# UNITED STATES PATENT AND TRADEMARK OFFICE

APPLICATION NO.	FILING DATE	FIRST NAMED INVENTOR	ATTORNEY DOCKET NO.	CONFIRMATION NO.
10/500,214	03/17/2005	Takuya Sugawara	010986.55104US	2535
23911	7590	02/03/2006	EXAMINER	
CROWELL & MORING LLP INTELLECTUAL PROPERTY GROUP P.O. BOX 14300 WASHINGTON, DC 20044-4300			ESTRADA, MICHELLE	
			ART UNIT	PAPER NUMBER
			2823

<b>Office Action Summary</b>	Application No. 10/500,214	Applicant(s) SUGAWARA ET AL.	
	Examiner Michelle Estrada	Art Unit 2823

## **DETAILED ACTION**

SUBSTITUTE DRAWING  
Attorney Docket No. 010986.55104US  
Application Serial No. 10/500,214

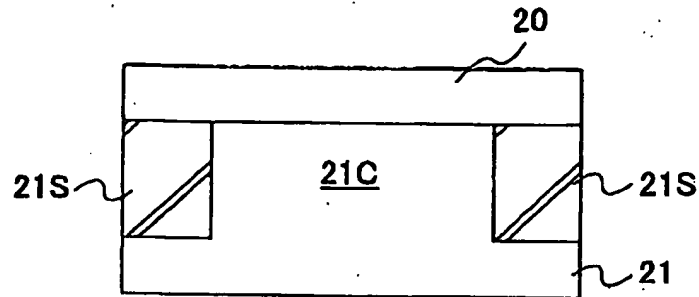
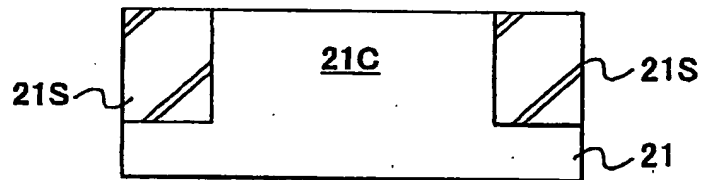
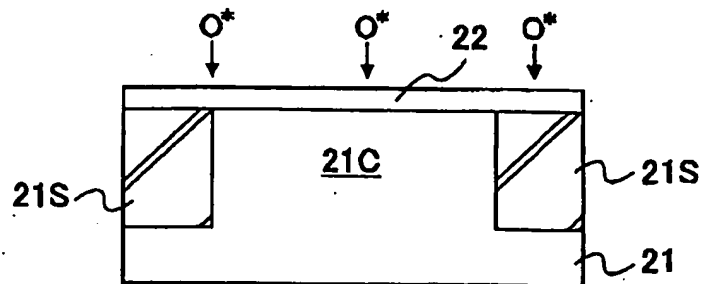
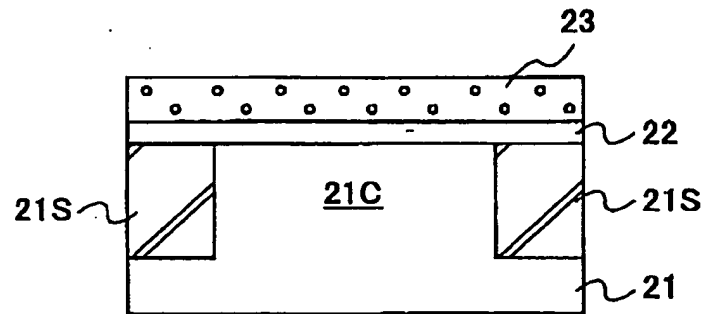
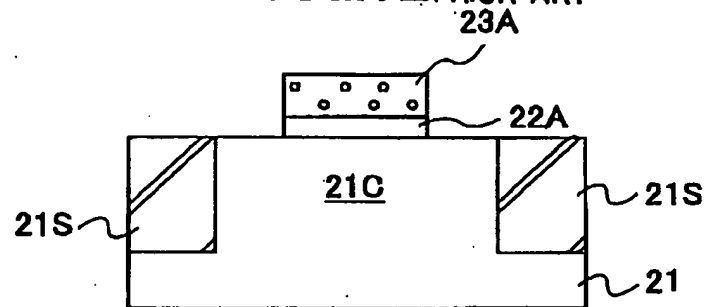
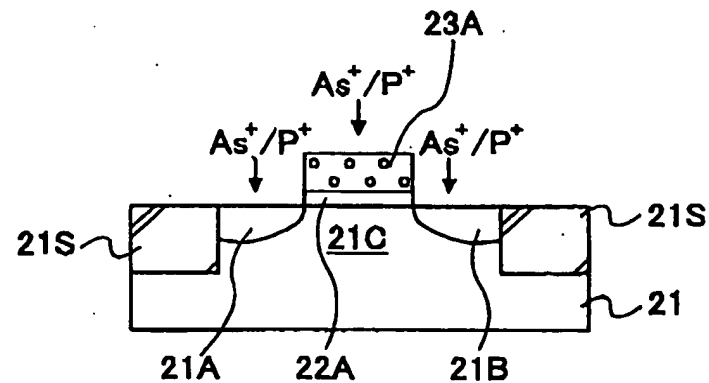
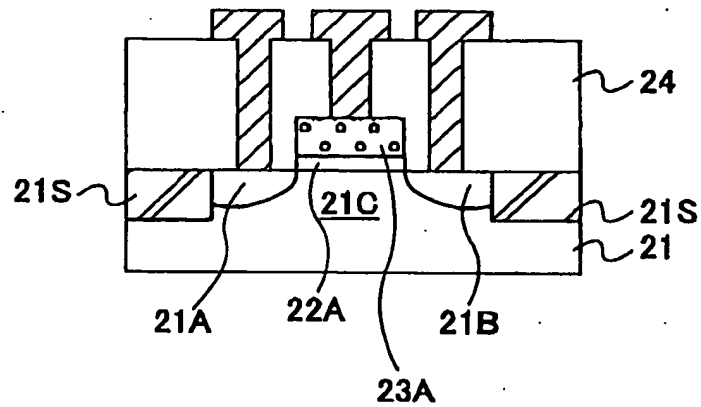
Re claim 11, AAPA discloses forming a gate insulation film (22A) on said substrate (21C); forming an electrode of polysilicon (23A) on said gate insulation film;

In canceled page 7, lines 7-13, describes Figs. 1A-1H as a "typical application" and this paragraph was moved to "Best Mode for Carrying Out the Invention", but this figures are labeled as "Prior Art". Furthermore, in the "Brief Description of the Drawings" on page 15, Figs. 1A-1H are described as diagrams showing a "previously proposed fabrication process" of a semiconductor device and Applicant agreed to labeled them as "Prior Art", but instead change their description under "Best Mode for Carrying Out the Invention".
